City of Tualatin

Self-Evaluation and Transition Plan: Appendix A: ADA Task Force Meeting Agendas

Self-Evaluation and Transition Plan:
Appendix C: Standard Plan and Specification
Review and Recommendations

DWG NO. 010

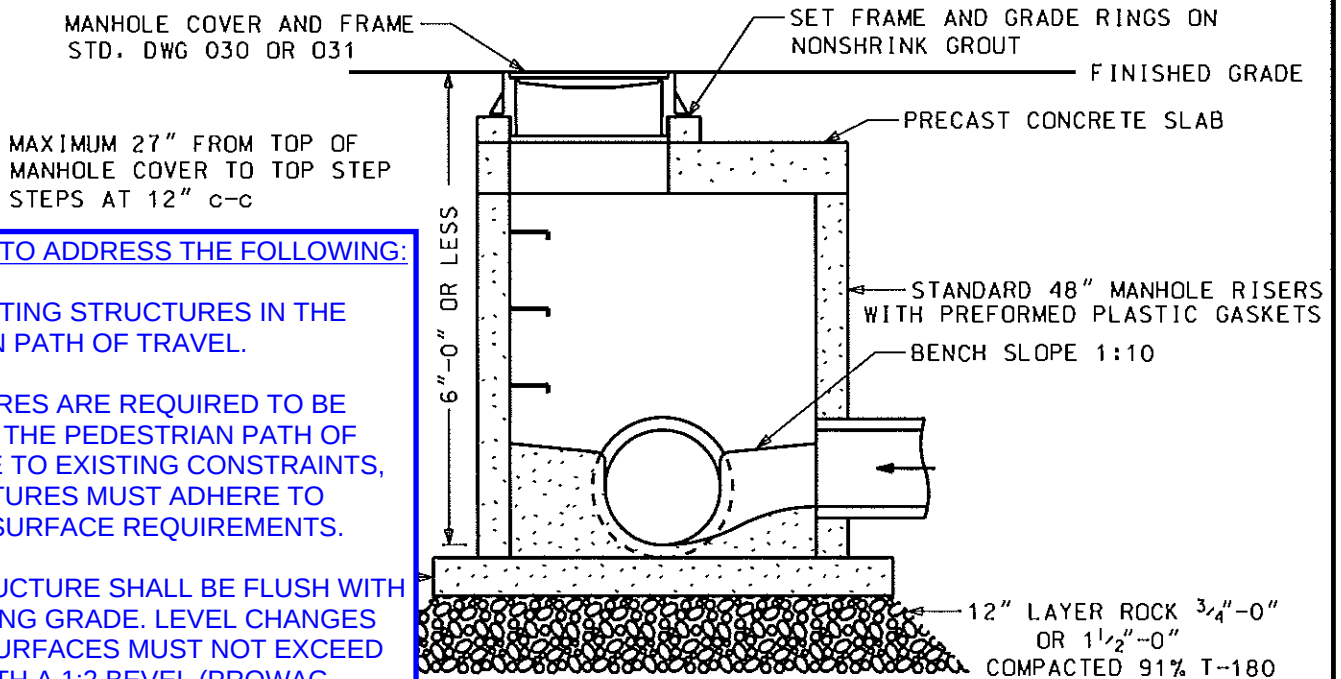
ADD NOTES TO ADDRESS THE FOLLOWING:

**MANHOLE
COVER AND FRAME
STANDARD**

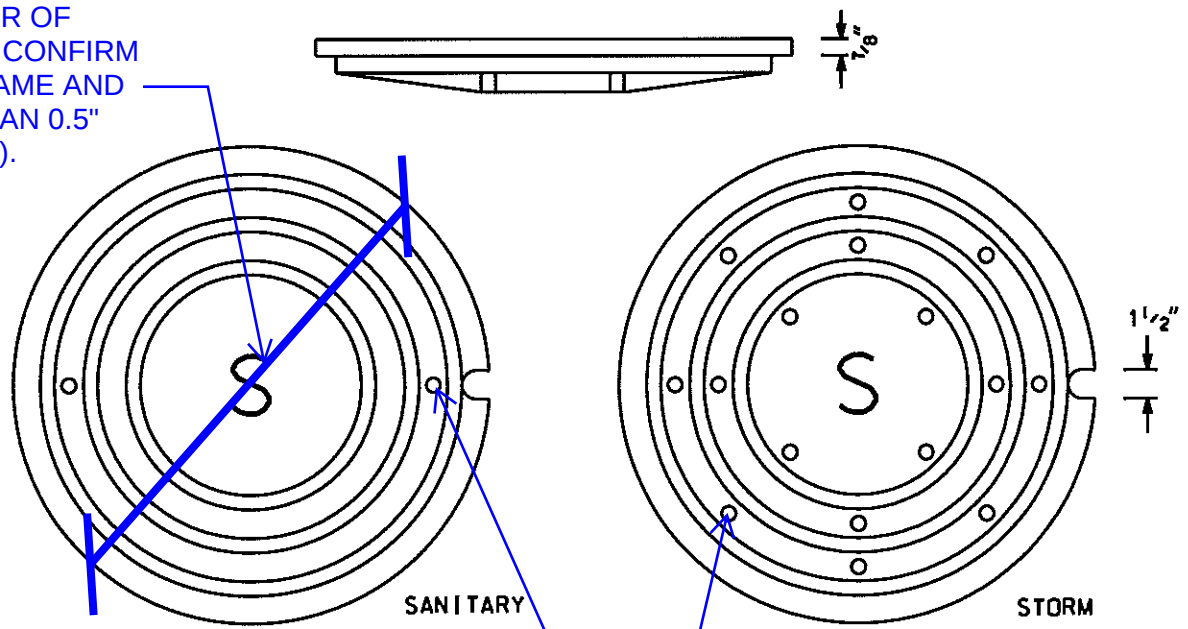
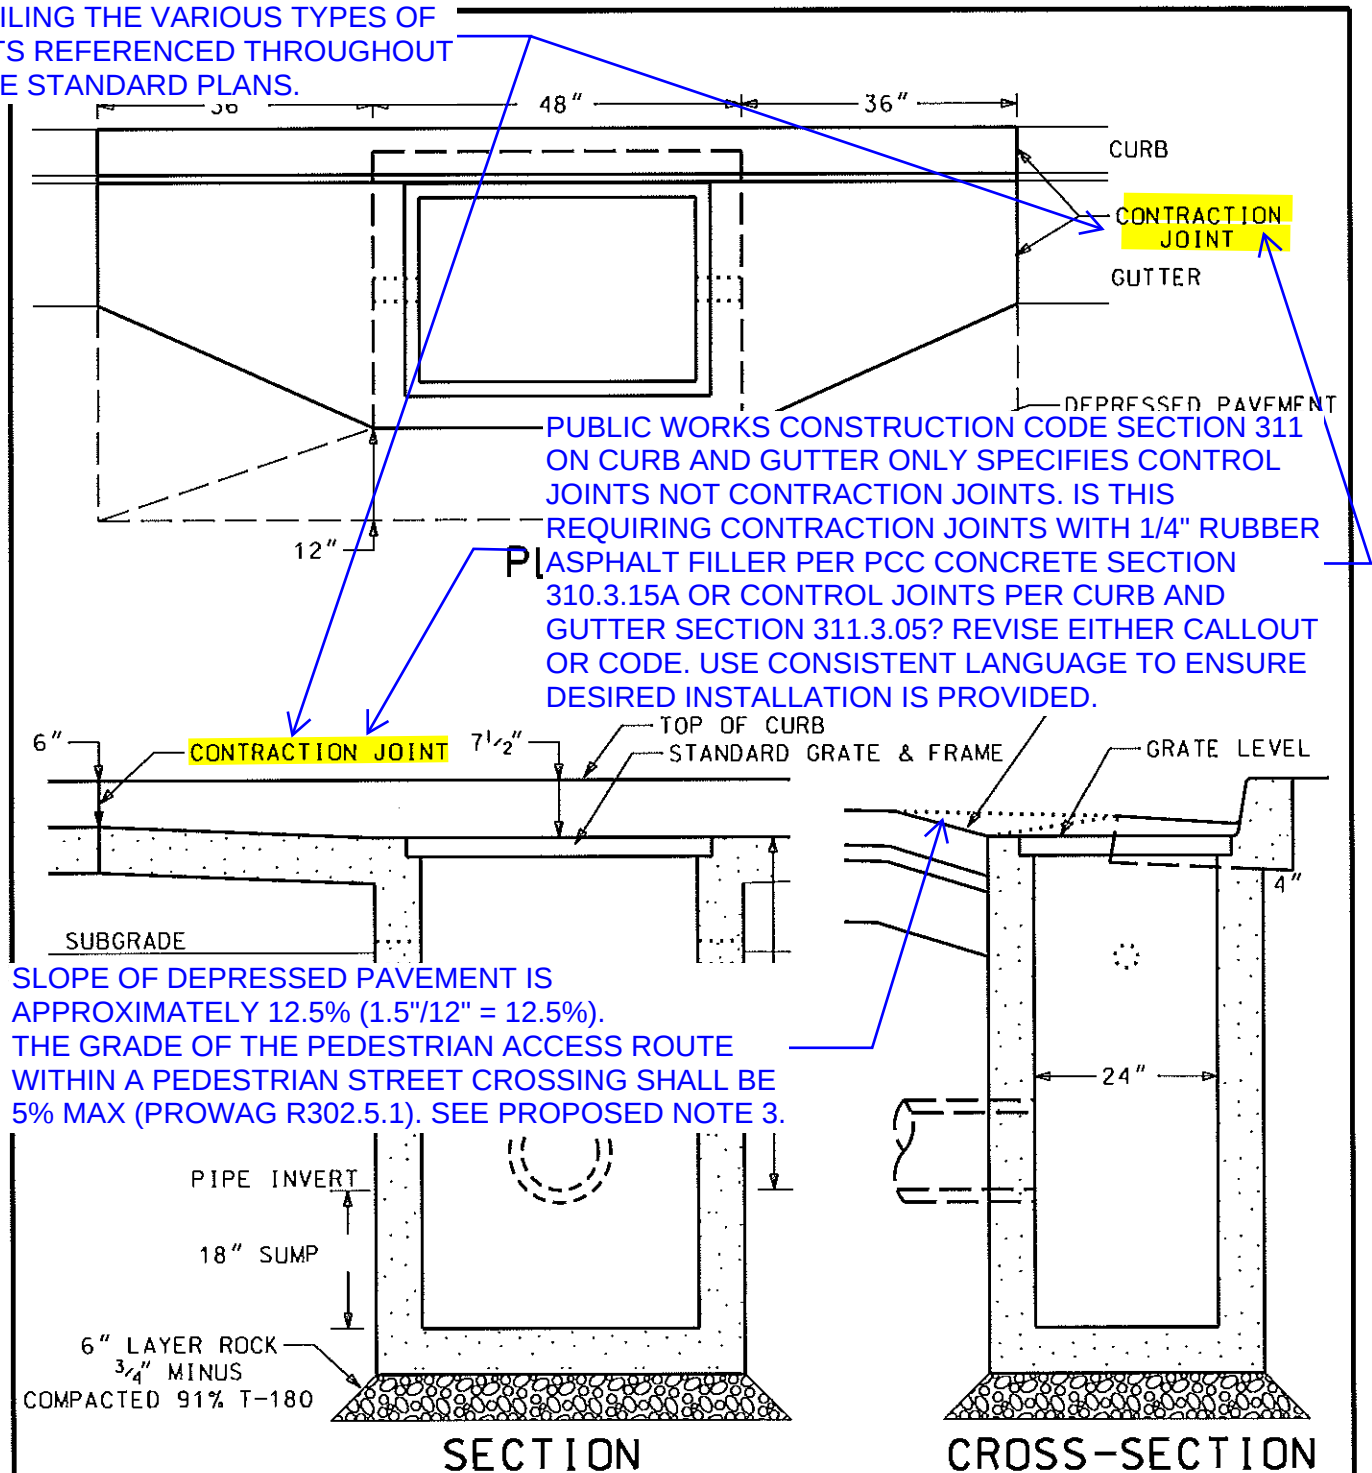
IDENTIFY DIAMETER OF MANHOLE COVER. CONFIRM GAP BETWEEN FRAME AND COVER IS LESS THAN 0.5" (PROWAG R302.7.3).

ADD NOTES TO ADDRESS THE FOLLOWING:

CURBSIDE PLANTER STRIP

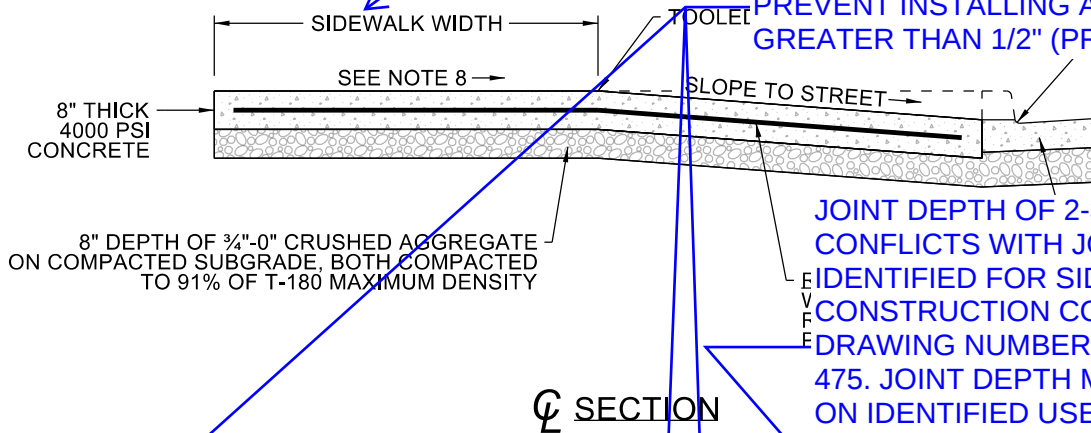
MINIMUM WIDTH OF SIDEWALK SHALL BE
48" MINIMUM EXCLUDING CURB WITH 5' MIN
BY 5' MIN PASSING SPACES PROVIDED AT
INTERVALS OF 200' MAXIMUM (PROWAG
R302.3 AND 302.4).

REDUCE 1/4" RADIUS TO 1/8" RADIUS TO
PREVENT INSTALLING A JOINT WITH A GAP
GREATER THAN 1/2" (PROWAG R302.7.3)

JOINT DEPTH OF 2-3/4" IN THIS DETAIL
CONFLICTS WITH JOINT DEPTH
IDENTIFIED FOR SIDEWALKS IN
CONSTRUCTION CODE 312.3.05 AND
DRAWING NUMBERS 442, 443 AND
475. JOINT DEPTH MAY VARY BASED
ON IDENTIFIED USE BUT IS NOT
SPECIFIED IN CONSTRUCTION CODE
FOR COMMERCIAL DRIVEWAYS.

CLARIFY IF NOTE 7 IS REQUIRING THE APPROACH SLAB AND
WINGS TO BE MONOLITHIC WITH THE CURB AND GUTTER OR
IF JUST THE CURB AND GUTTER IS MONOLITHIC.

CURBSIDE SIDEWALK

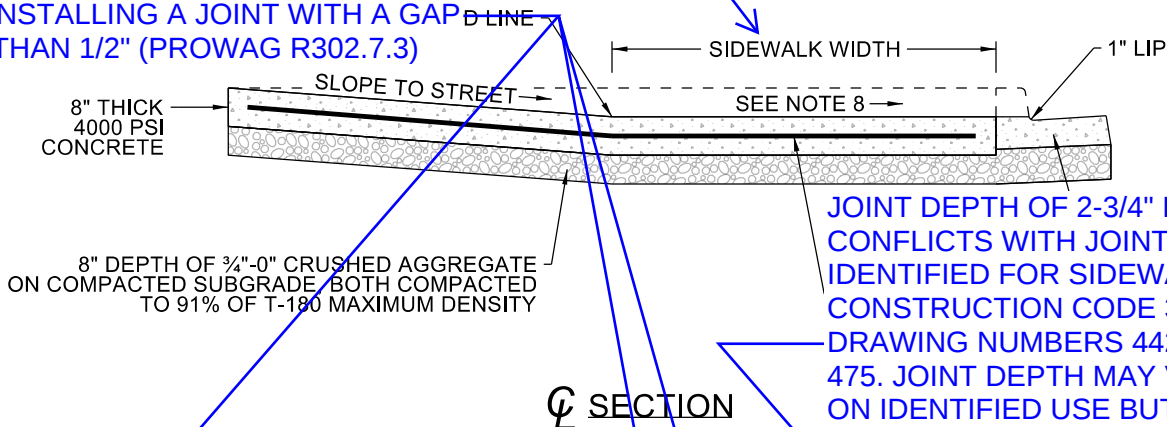
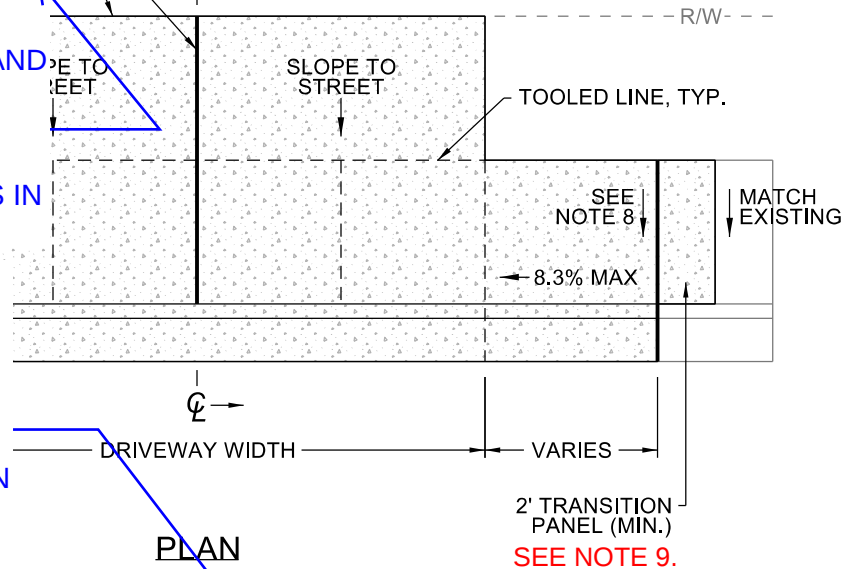
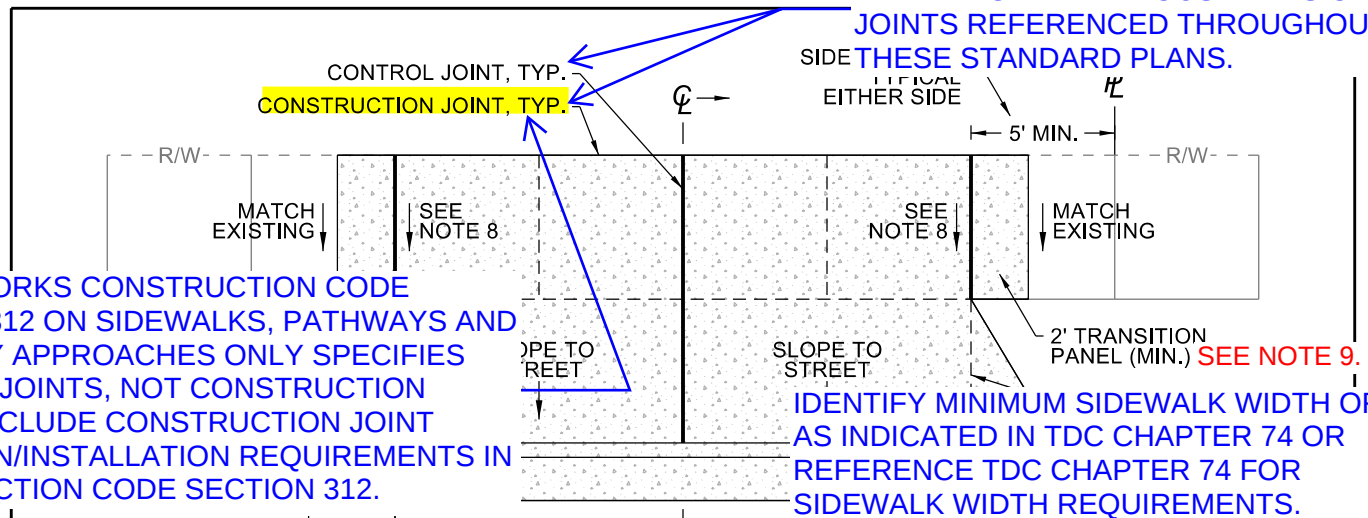
PUBLIC WORKS CONSTRUCTION CODE
SECTION 312 ON SIDEWALKS, PATHWAYS AND
DRIVEWAY APPROACHES ONLY SPECIFIES
CONTROL JOINTS, NOT CONSTRUCTION
JOINTS. INCLUDE CONSTRUCTION JOINT
DEFINITION/INSTALLATION REQUIREMENTS IN
CONSTRUCTION CODE SECTION 312.

CLARIFY IF NOTE 7 IS REQUIRING THE APPROACH SLAB AND WINGS TO BE MONOLITHIC WITH THE CURB AND GUTTER OR IF JUST THE CURB AND GUTTER IS MONOLITHIC.

442

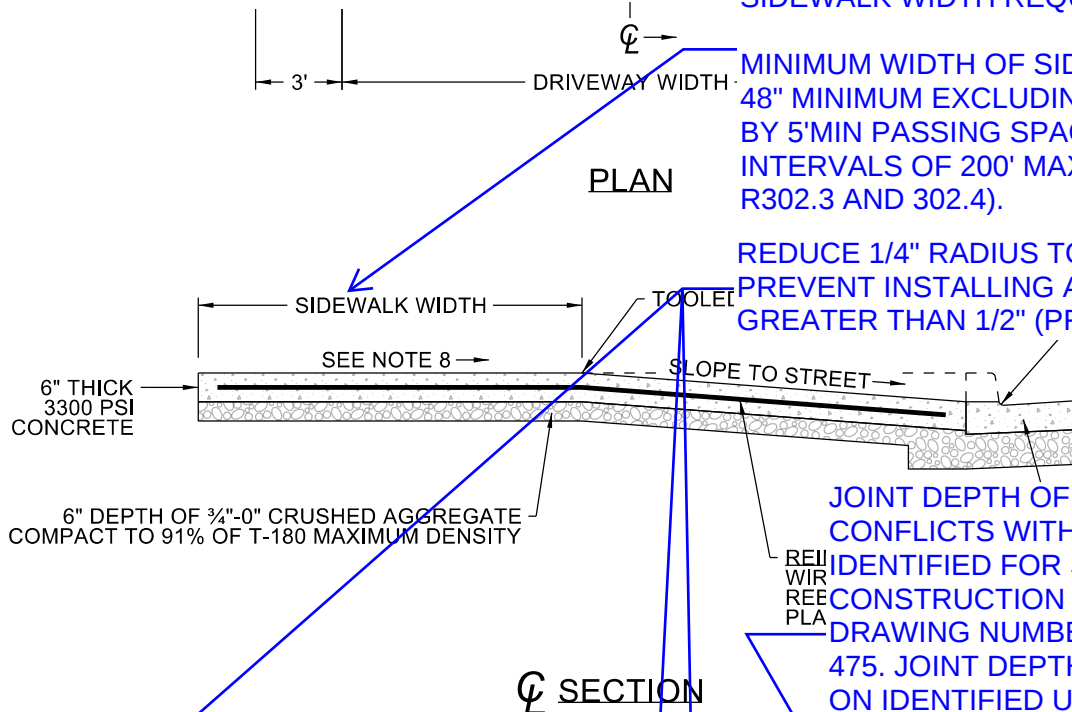
MINIMUM WIDTH OF SIDEWALK SHALL BE
48" MINIMUM EXCLUDING CURB WITH 5' MIN
BY 5' MIN PASSING SPACES PROVIDED AT
INTERVALS OF 200' MAXIMUM (PROWAG
R302.3 AND 302.4).

REDUCE 1/4" RADIUS TO 1/8" RADIUS TO
PREVENT INSTALLING A JOINT WITH A GAP
GREATER THAN 1/2" (PROWAG R302.7.3)

JOINT DEPTH OF 2" IN THIS DETAIL
CONFLICTS WITH JOINT DEPTH
IDENTIFIED FOR SIDEWALKS IN
CONSTRUCTION CODE 312.3.05 AND
DRAWING NUMBERS 440, 441 AND
475. JOINT DEPTH MAY VARY BASED
ON IDENTIFIED USE BUT IS NOT
SPECIFIED IN CONSTRUCTION CODE
FOR RESIDENTIAL DRIVEWAYS.

CLARIFY IF NOTE 7 IS REQUIRING THE APPROACH SLAB AND WINGS TO BE MONOLITHIC WITH THE CURB AND GUTTER OR IF JUST THE CURB AND GUTTER IS MONOLITHIC.

DRAWING NO: 462

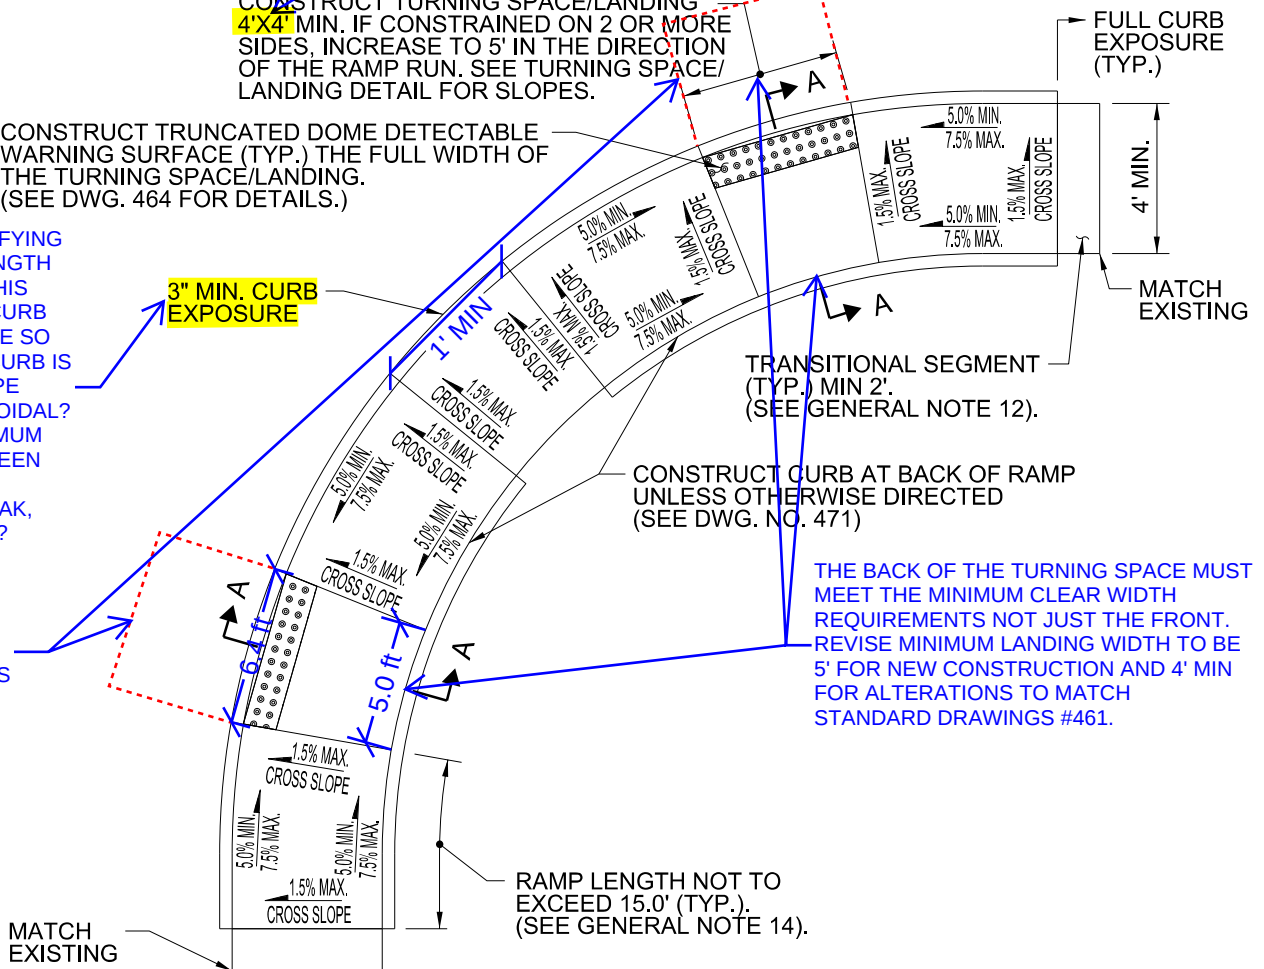
REVISE MINIMUM SIZE OF TURNING SPACE TO BE AT LEAST AS WIDE AS THE CURB RAMP BY 4' MIN.

IS THIS MIN 3" IDENTIFYING A MINIMUM CURB LENGTH OR HEIGHT? DOES THIS DETAIL ALLOW THE CURB TO COME TO AN EDGE SO THAT THE FACE OF CURB IS TRIANGULAR IN SHAPE INSTEAD OF TRAPEZOIDAL? RECOMMEND 1' MINIMUM CURB LENGTH BETWEEN RAMPS, OTHERWISE, CONCRETE MAY BREAK, CRACK OR UNRAVEL?

SHOW CLEAR SPACES AND ADD A CALLOUT IDENTIFYING CLEAR SPACE REQUIREMENTS PER DWG. NO. 464.

REVISE TO 4.0% MAX SLOPE TO ALLOW FOR CONSTRUCTION TOLERANCE.

REVISE MINIMUM SIZE OF TURNING SPACE TO BE 4' MIN AND AT LEAST AS WIDE AS THE CURB RAMP.

DRAWING NO: 463

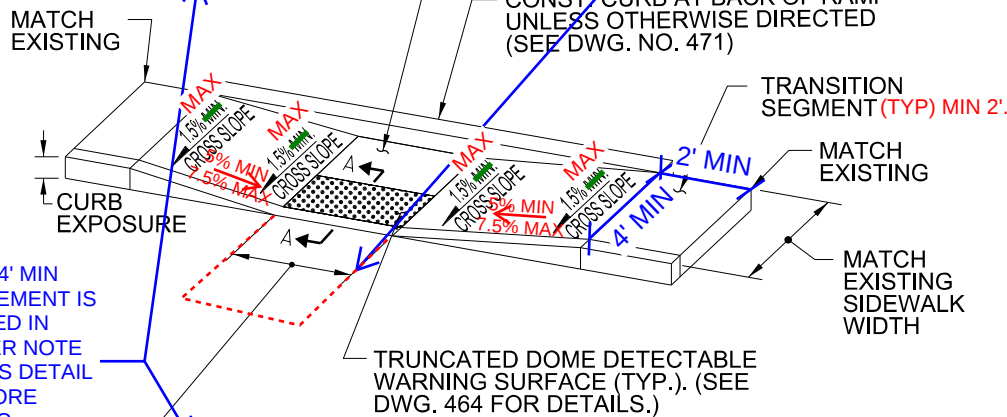
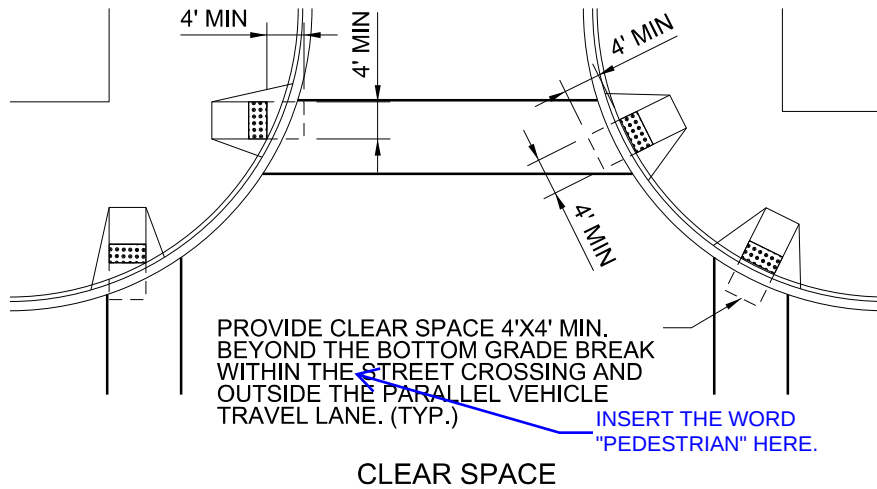
REVISE MINIMUM SIZE OF TURNING SPACE TO BE AT LEAST AS WIDE AS THE CURB RAMP BY 4' MIN. ADD WORDING FROM TURNING SPACE CALLOUT BELOW REQUIRING THE LENGTH OF THE TURNING SPACE TO INCREASE TO 5' IN THE DIRECTION OF THE RAMP RUN IF CONSTRAINED ON TWO OR MORE SIDES.

SHOW CLEAR SPACES AND ADD A CALLOUT IDENTIFYING CLEAR SPACE REQUIREMENTS PER DWG. NO. 464.

REVISE TO 4.0% MAX SLOPE TO ALLOW FOR CONSTRUCTION TOLERANCE.

THIS 4'X4' MIN REQUIREMENT IS INCLUDED IN ANOTHER NOTE FOR THIS DETAIL WITH MORE SPECIFIC REQUIREMENTS.

REVISE MINIMUM SIZE OF TURNING SPACE TO BE AT LEAST AS WIDE AS THE CURB RAMP(4' MIN) BY 4' MIN.

CURB AND GUTTER

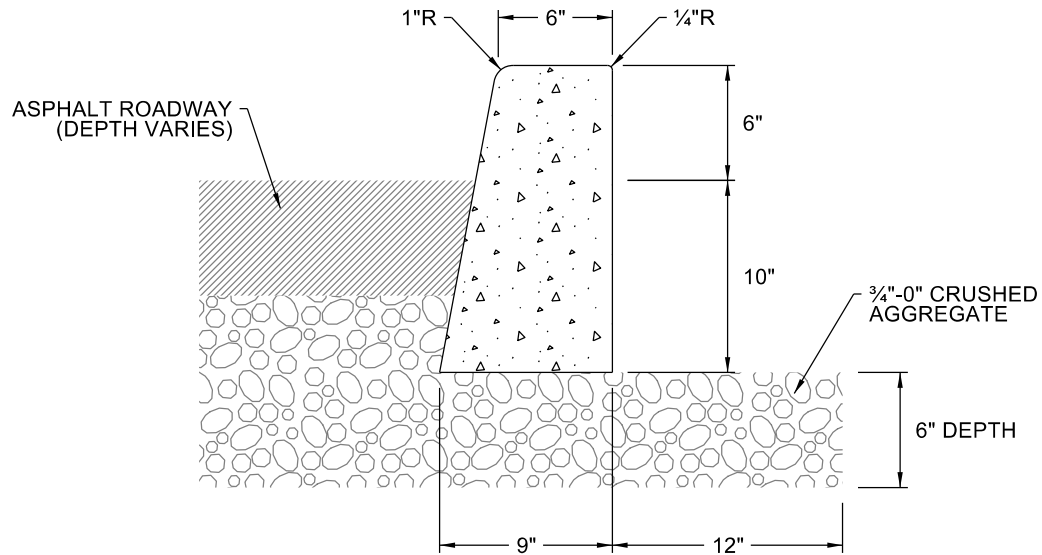
ADD A NOTE TO REDUCE SLOPE OF
GUTTER TO LESS THAN 5% MAX
ACROSS THE PEDESTRIAN ROUTE AT
CURB RAMP LOCATIONS.

ADD TO NOTES 2 AND 3 TO AVOID PLACING JOINTS WITHIN
THE PEDESTRIAN ROUTE AT CURB RAMP LOCATIONS.

ADD TO NOTE 5, IF SIDEWALK IS ADJACENT TO CURB, EXTEND PIPE UNDER THE SIDEWALK
TO THE RW LINE PER NOTE 1 IN DETAIL 475.

CURB

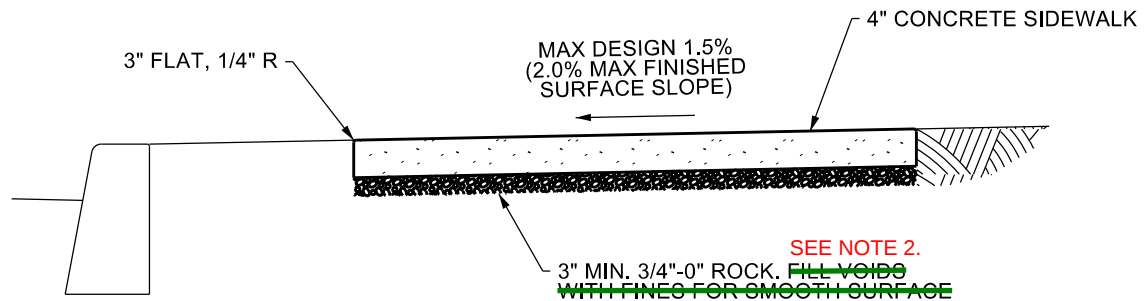
ADD TO NOTE 5, IF SIDEWALK IS ADJACENT TO CURB, EXTEND PIPE UNDER THE SIDEWALK TO THE R/W LINE PER NOTE 1 IN DETAIL 475.
